ADDENDUM NO. 4

DATE: November 10, 2011

Contract 11-C-00017; Tampa Riverwalk Segment 17 Cass Street Connection

**INSTALL RAILING
BARRIER AT EXISTING WALKWAY**

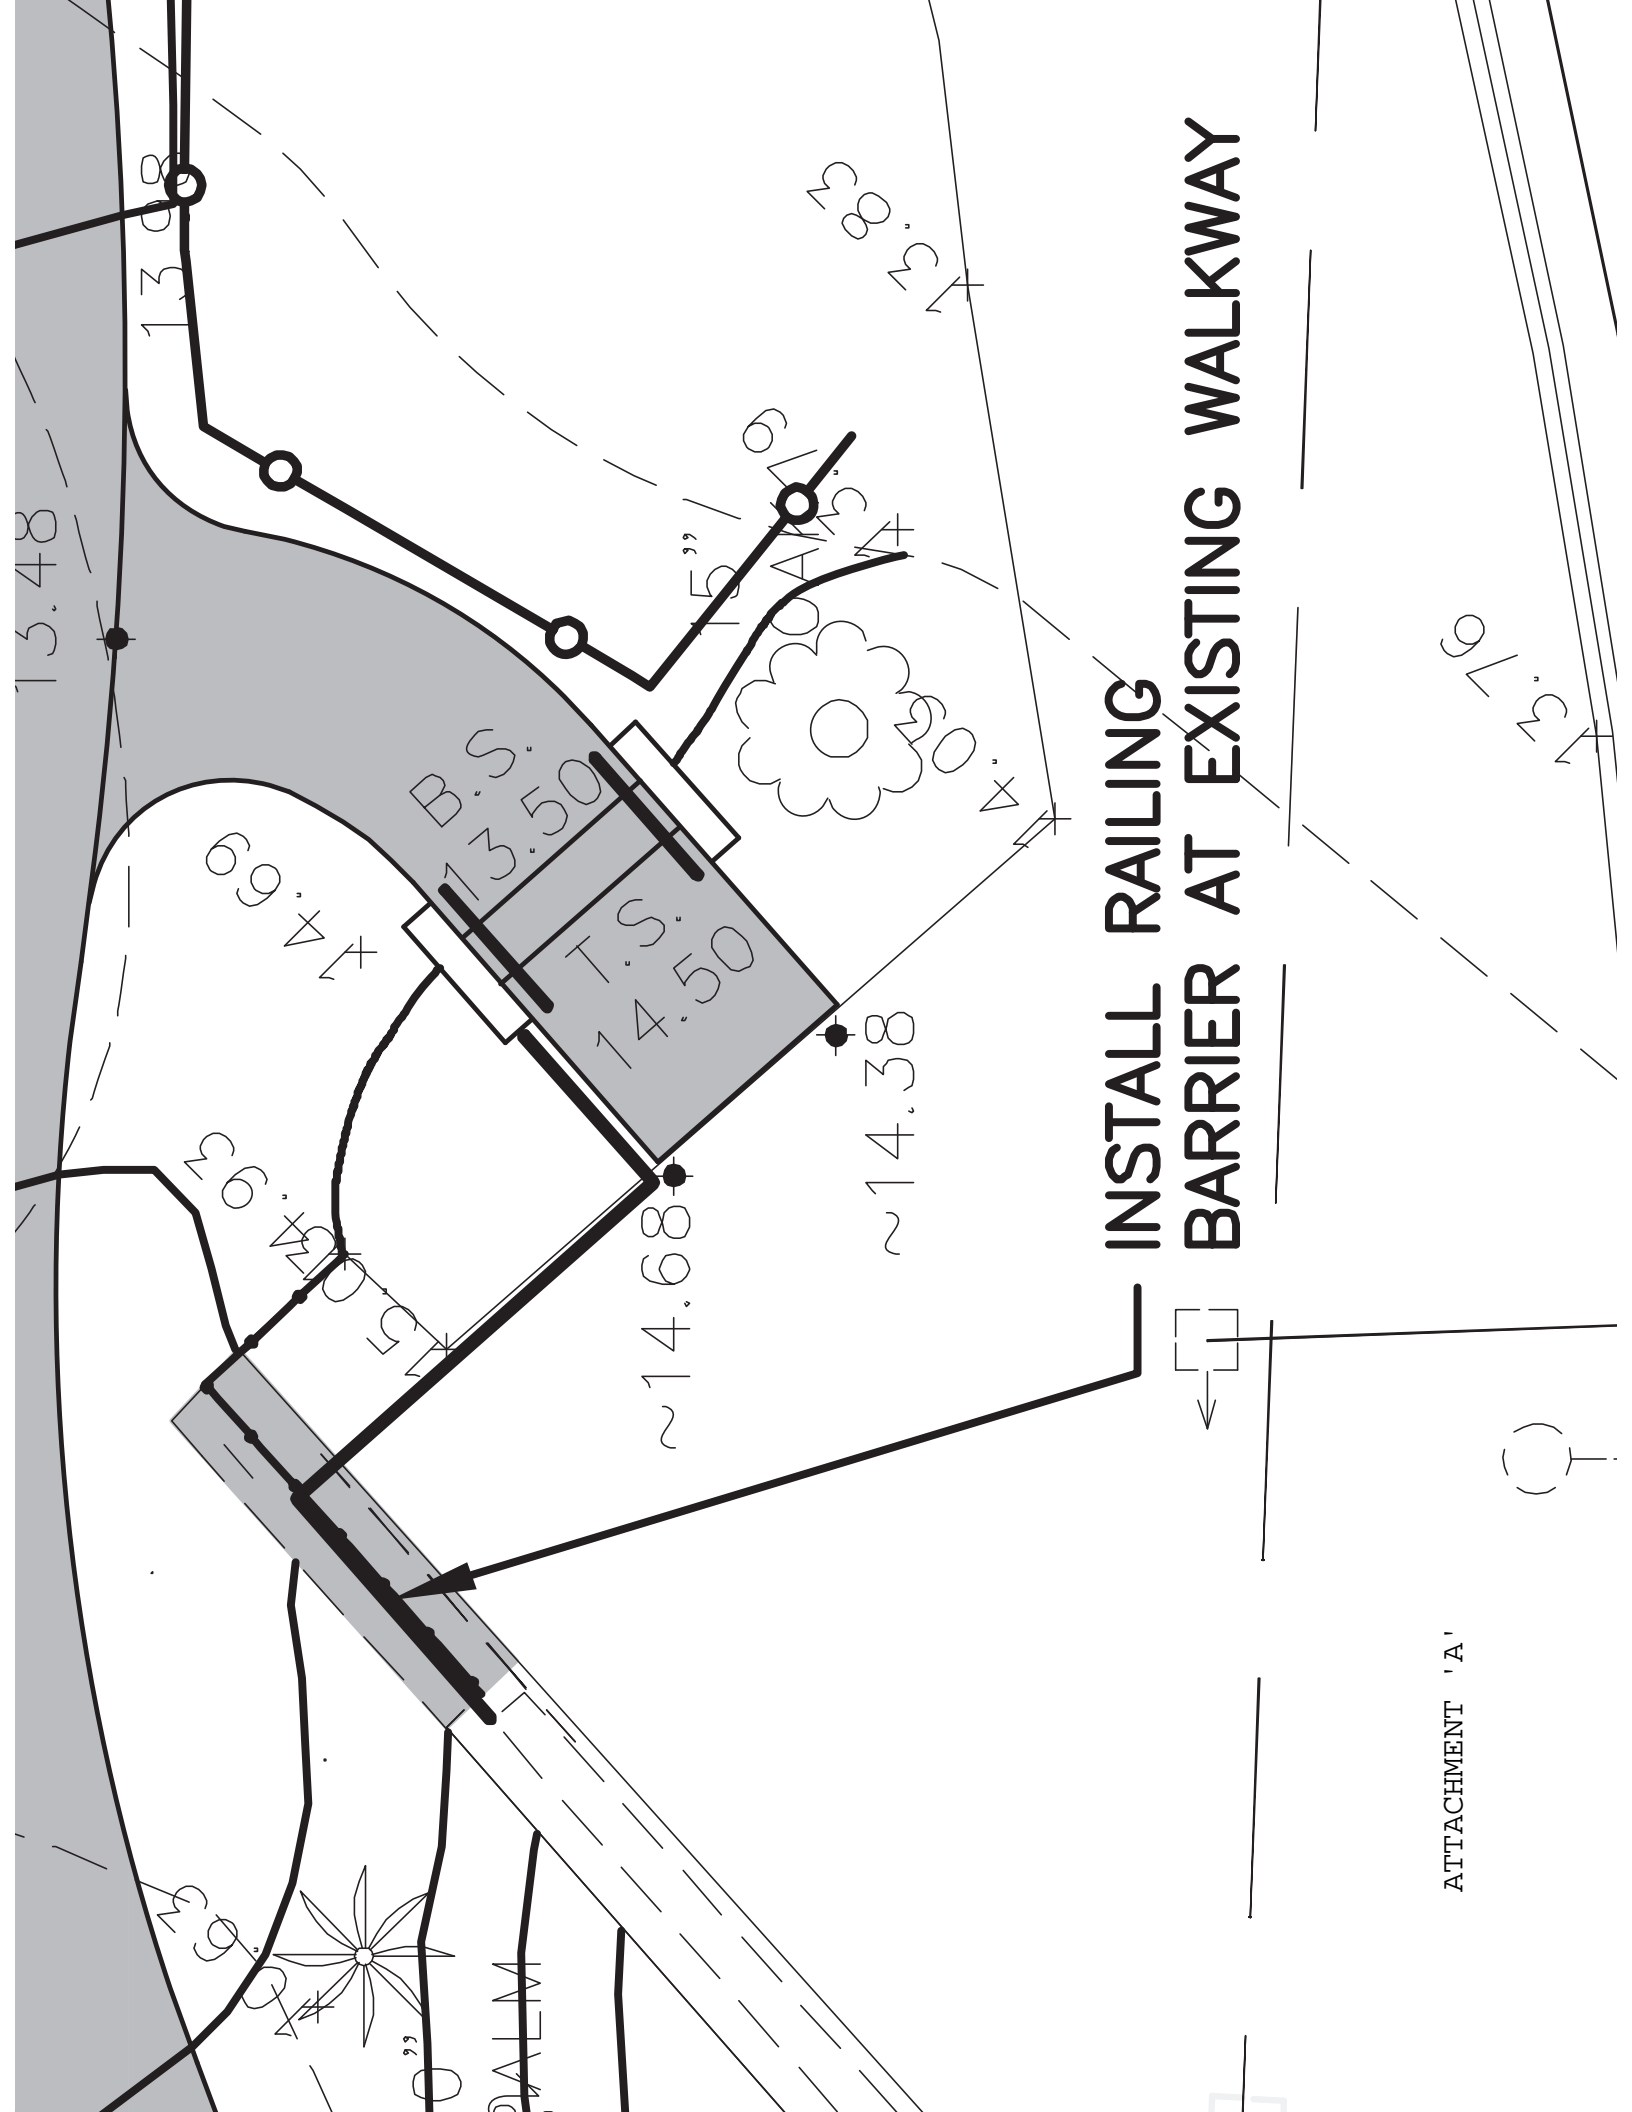
- Item 4: Railing System Clarification: Railing System #2 - Barrier is for the bridge abutment opening after demolition of the bridge stairs. Refer to attached photo of railing design configuration intended for this location. The rail system shall be powder-coated aluminum with horizontal rails and vertical posts, surface mounting with drilled integral foot plate attached with bolts epoxied to existing concrete slab.
- Item 5: Sheet C-02; Note 1 Clarification: Intent of bid documents is for complete removal. Add contingency allowance of \$20,000. See revised proposal sheets.

TYPICAL SECTION—UNREINFORCED RETAINING WALL
 N.T.S.

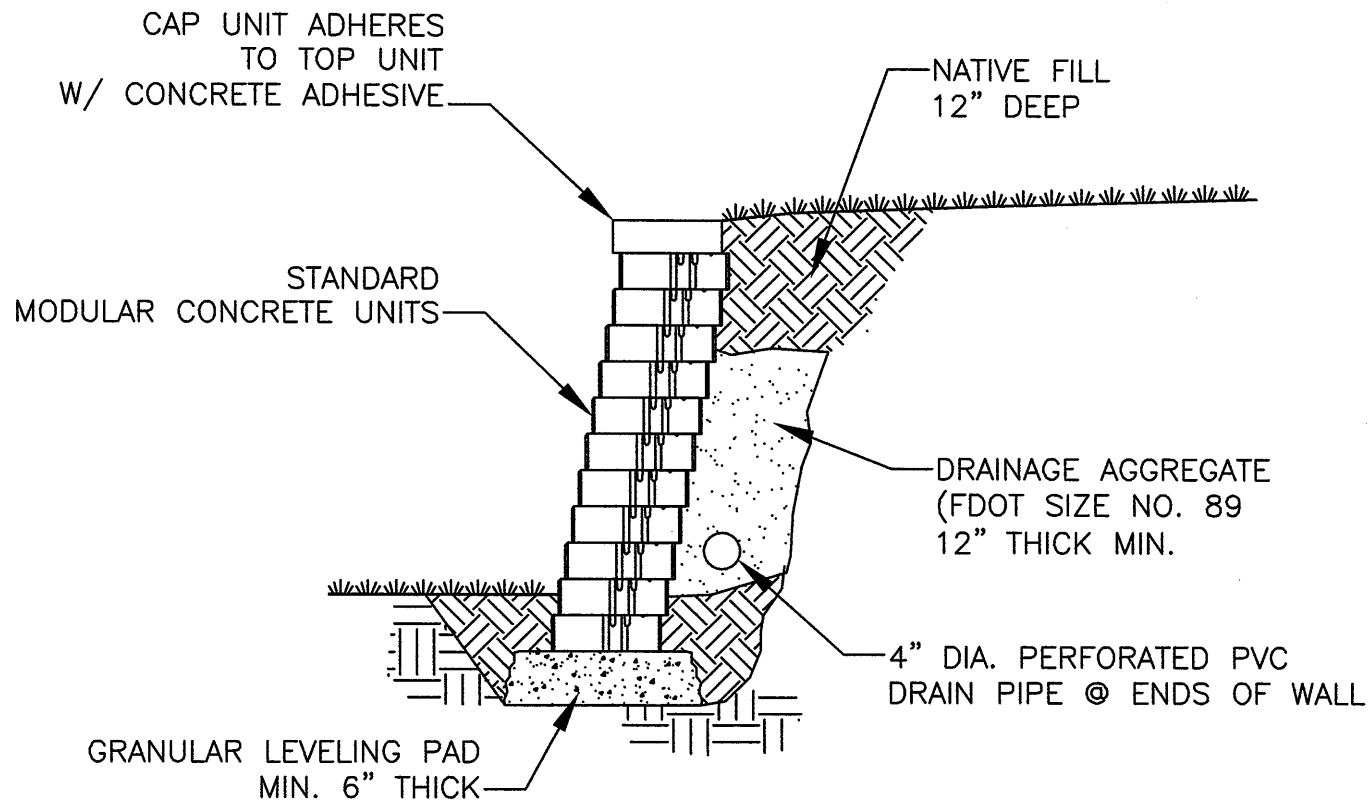
- Item 11: Segmented Wall Sheet C-04 Clarification: Bid basis for wall is Versa-Lok, Geo-stone or equal. See Attachment 'B' for detail.
- Item 12: Irrigation System tie in Clarification: New irrigation system shall tie into main line located along sea wall. See sheet C-01 for irrigation valve cover located near seawall.
